BEN LOMAND MOUNTIAN VILLAGE

EL PASO COUNTY, CO

PRELIM PLANS - NOT FOR CONSTRUCTION

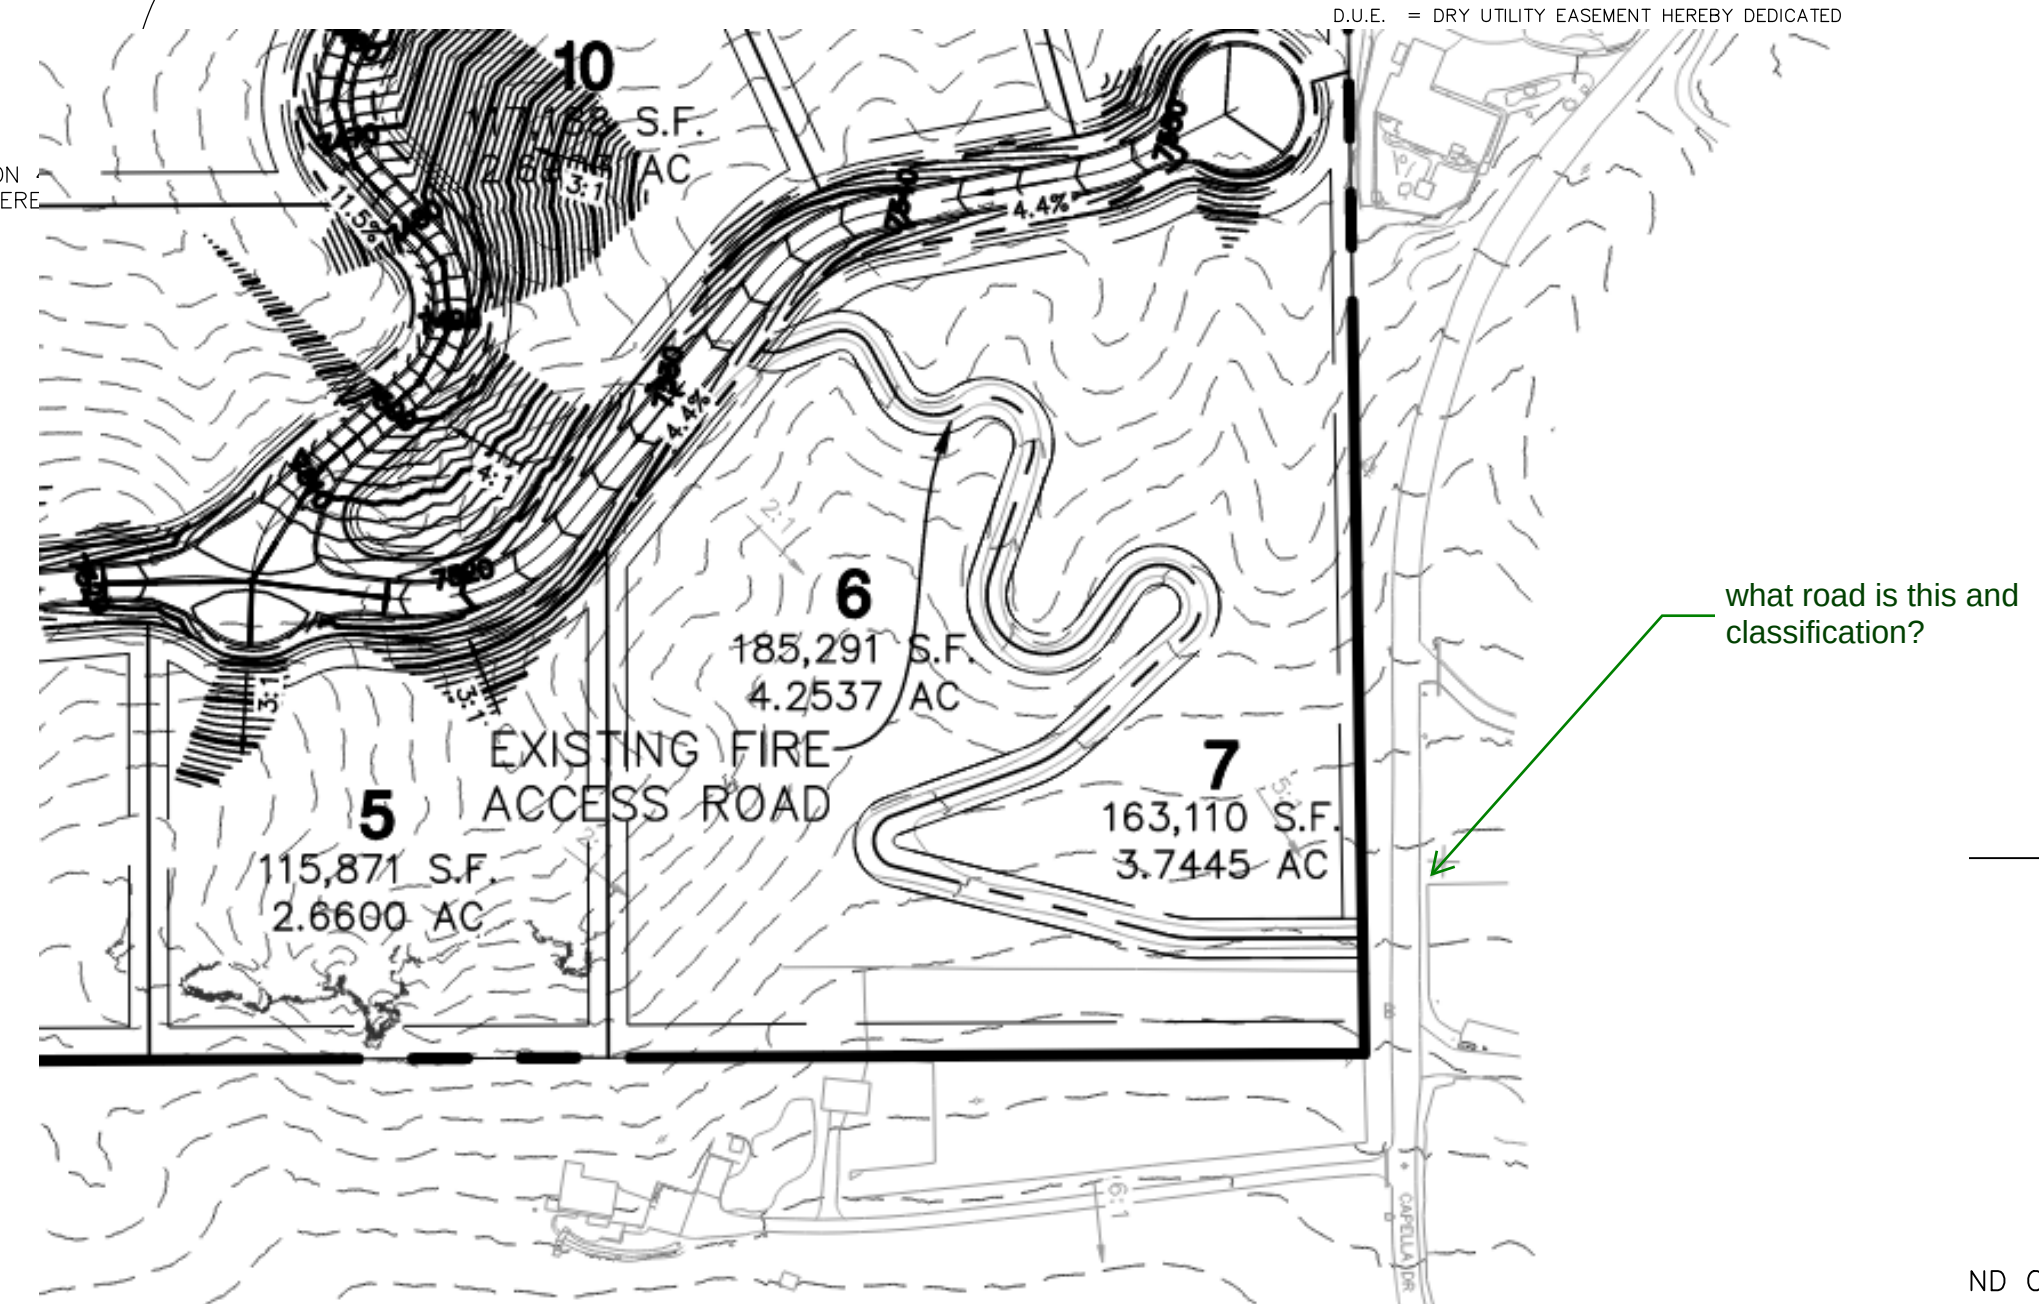
Please address and reconfigure.

(e) Lots Divided by Easements. Lots should not be divided by easements. Drainage easements which bisect a lot are only allowed where no reasonable alternative to the drainage solution exists.

(5) Division of Lots by Boundaries and Man-Made or Natural Features.
(a) Roads or Other Lots. Lot shall not be divided by a road, alley, or another lot.

Please show slope/rockfall hazard (no-build) areas and building envelopes. Please address fire access issues in the LOI with driveways over 150ft.

what road is this and classification?

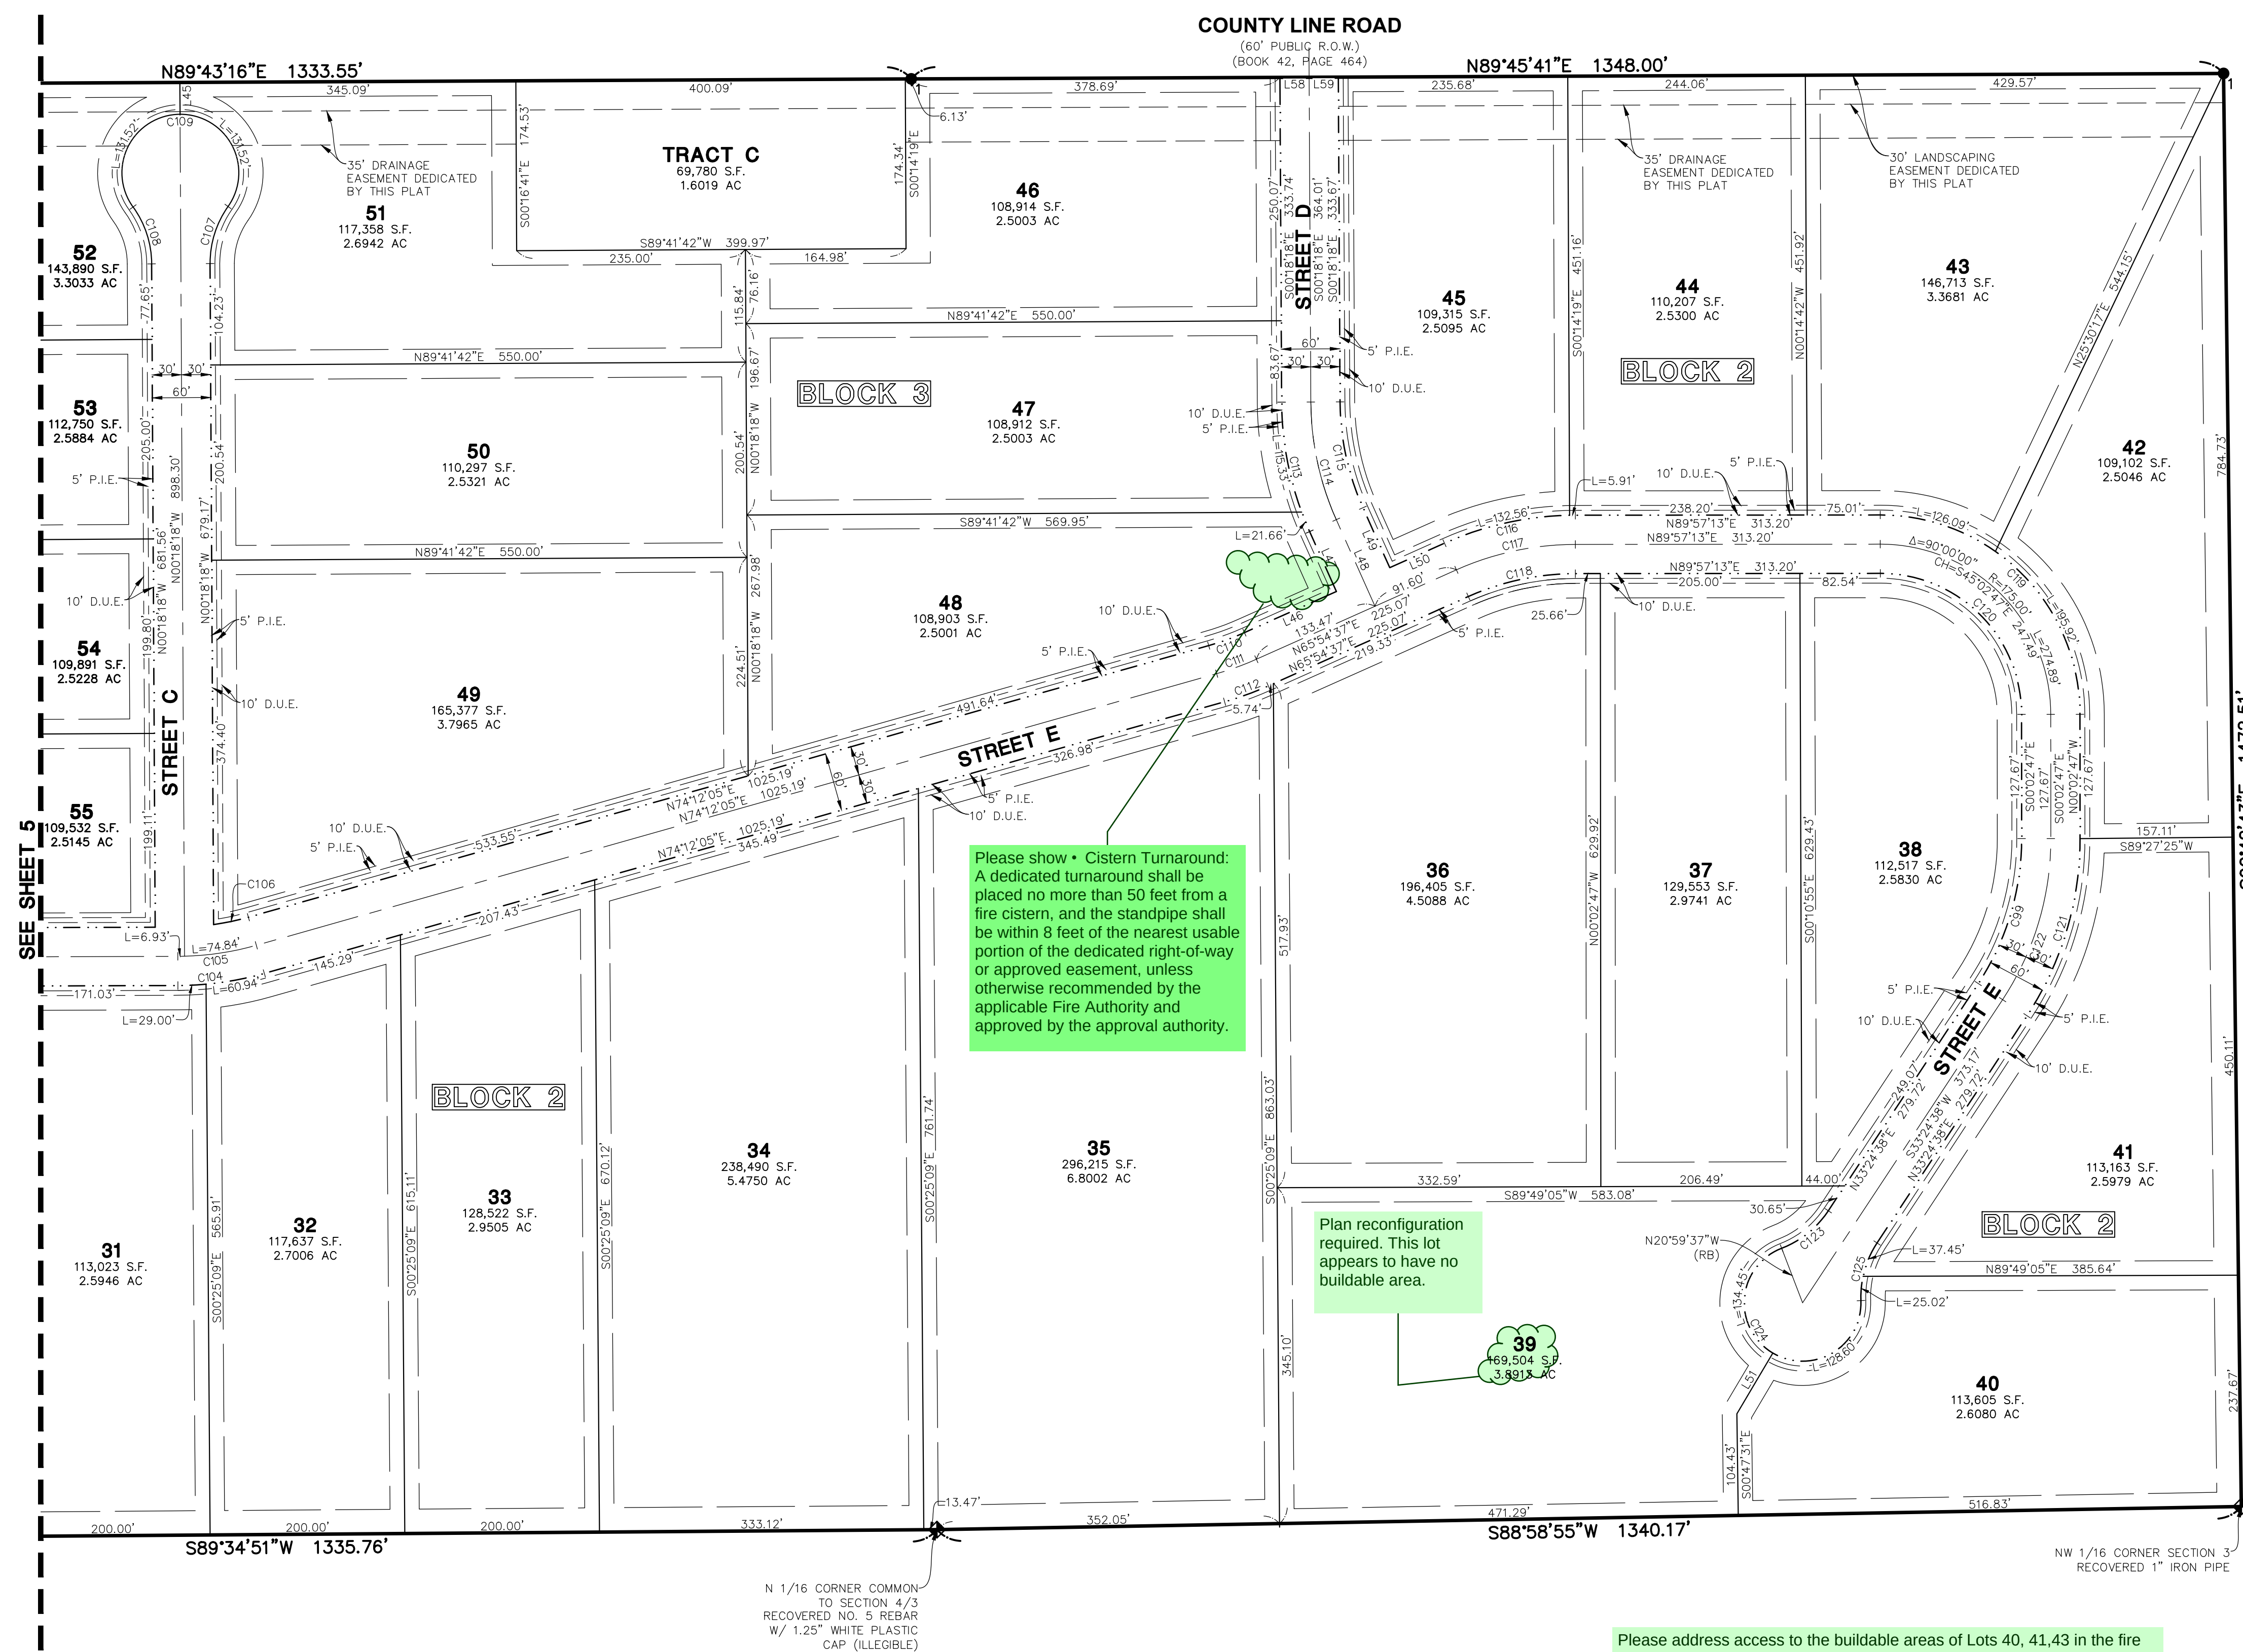
Please show all hazards as detailed in the soils and geo report. Including ponds, drainage easements, etc. Label as "No-Build easement"

Please label wetland areas and pond as "No-build easement"

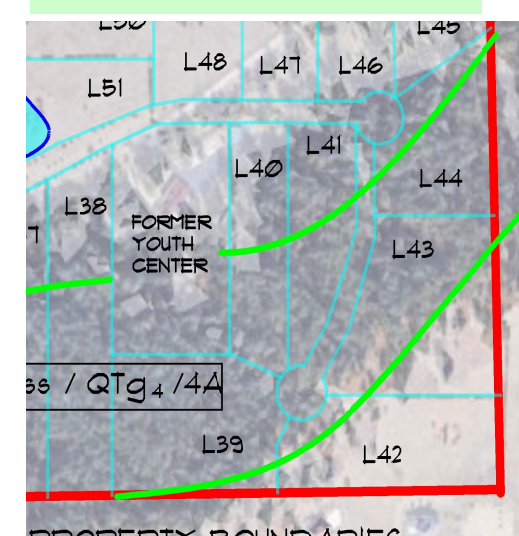
Please show all hazards as detailed in the soils and geo report. Including ponds, drainage easements, etc. Label as "No-Build easement"

Please show building envelopes for lots affected by major slope/hazard constraints.

When building envelopes are utilized on the plat: Building envelopes indicate areas allowing residential construction and are more restrictive than the setbacks required by zoning and will govern all building placement. The building envelopes are used to describe purpose: avoid soil hazards, avoid rock outcroppings, protect wetlands, etc.. Building envelopes shall contain the primary residential structure, any accessory structures, the well, and the On-Site Wastewater system, unless otherwise noted.

OVERALL GRADING

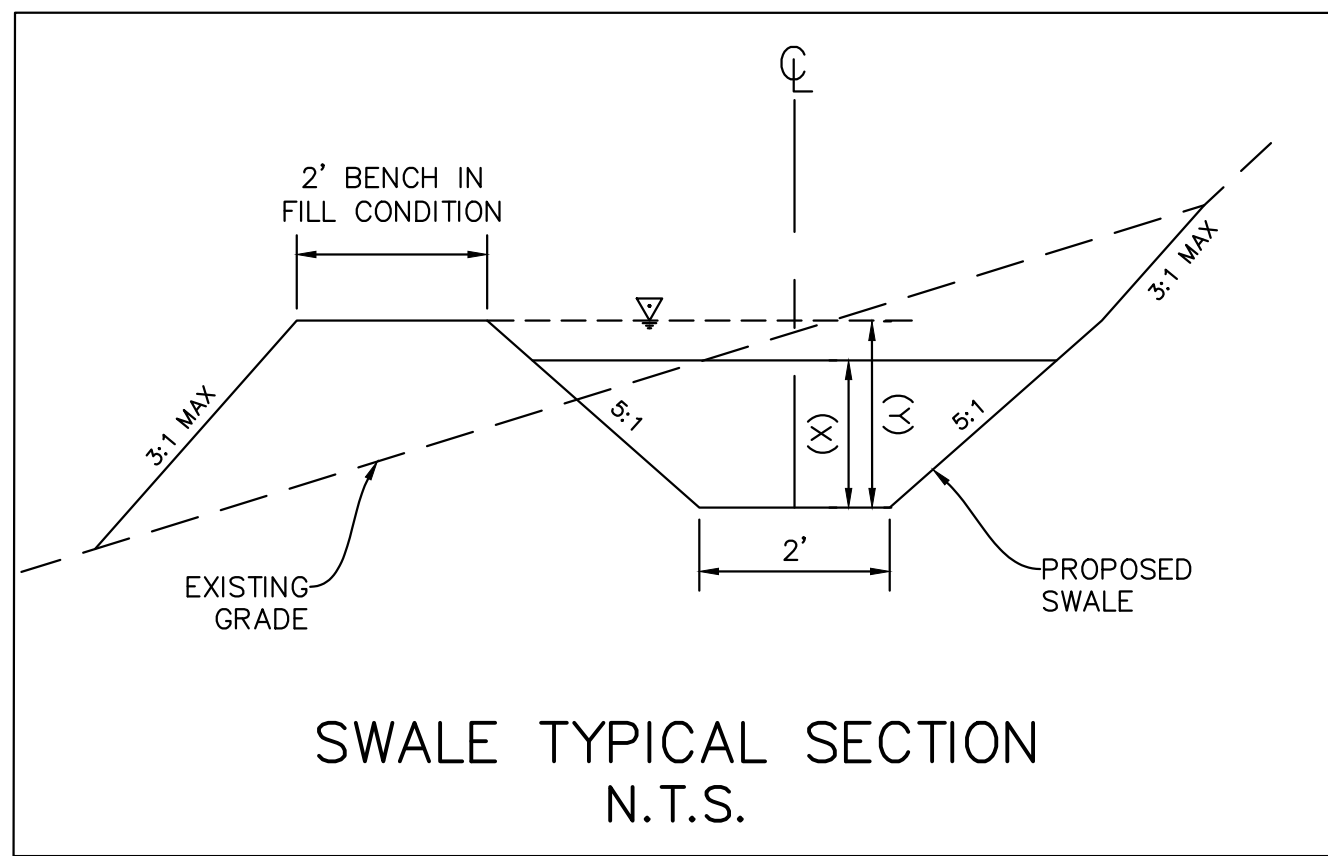
please remove a lot ; lots are required to be 2.5 acres in the RR-2.5 zoning district per a condition of approval

the detention basins are in conflict with the potential dedication of 15' for the prescriptive ROW for County Line Road.

Add the following note here " No direct lot access is allowed to County Line Road".

Add Standard Notes for El Paso County Construction Plans, use the following link to download them (make sure to fill and complete number 16):
<https://publicworks.elpasoco.com/departament-public-works/county-engineer/#docacc-ess-7cebb6510a913aad9810495307fc6dd1dd19f4a6b84264dbd31846c74faaa7e>

Typical where it occurs: Max cut-de-sac length is 1600, per ECM 2.3.8 Deviation will not be considered without an expressed written endorsement from the FIRE District.

All roads must meet EPC maximum slopes requirements (No deviations will accepted).

No work is allowed on slopes greater than 30% slopes.

Add a "street name" sign plan.
